URGENT SAFETY NOTICE

- Survivair Panther TwentyTwenty Plus® CBRN Facepiece nozzle found on 2420XX series facepieces.
- Survivair Panther TwentyTwenty Plus® CBRN Facepiece Air Klik found on 2420XX series facepieces.
- Survivair Panther TwentyTwenty Plus® Facepiece nozzle found on 2220XX, 2320XX, 2520XX, and 2620XX series facepieces.

Figure 1

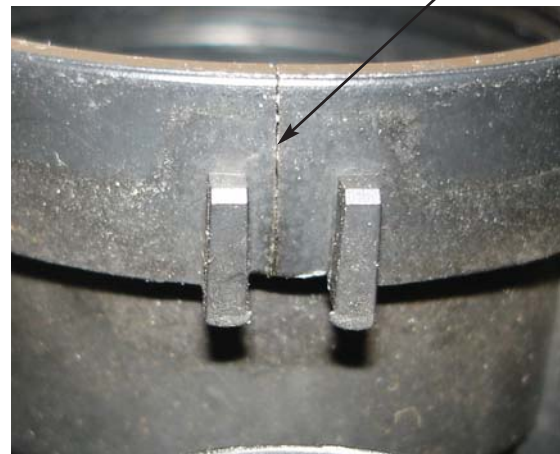
It has been determined that the Survivair TwentyTwenty Plus® Facepiece nozzle has the potential to crack at the molding knit line if the Air Klik is over-tightened as shown in **Figure 1**. Please note that the mold knit line as shown in **Figure 2** is normal and acceptable as long as the plastic has not cracked and separated as shown in **Figure 1**. If you are uncertain as to whether there is a normal knit line or a crack in your nozzle, attempt to spread the plastic apart. If it is a crack, the plastic will separate.

Crack spread open due to over-tightened Air Klik

Crack without Air Klik

Inspect your 2420XX series facepieces to see if they have a crack in the nozzle as shown in **Figure 1**. If any of the facepieces have a crack in the nozzle as shown in **Figure 1**, remove them from service and replace the nozzle with a new modified nozzle and Air Klic prior to returning the facepiece to service. If any of your 2420XX facepieces **DO NOT** have the modified nozzle as shown in **Figure 3**, and **DO NOT** have a crack in the nozzle as shown in **Figure 2**, they may be put back into service temporarily, but only until the nozzle can be replaced with a new modified nozzle and Air Klic. Contact Survivair by fax using the attached Fax Form to receive nozzle and Air Klic replacement kits.

It is possible that the Air Klic in your CBRN facepiece may have been over-tightened at the factory during the production process. Since it is not possible to know if your Air Klic was over-tightened, we are advising all users of CBRN facepieces to replace the nozzle and Air Klic in their facepiece with a new nozzle and Air Klic as described below and provided in kits available from Survivair.
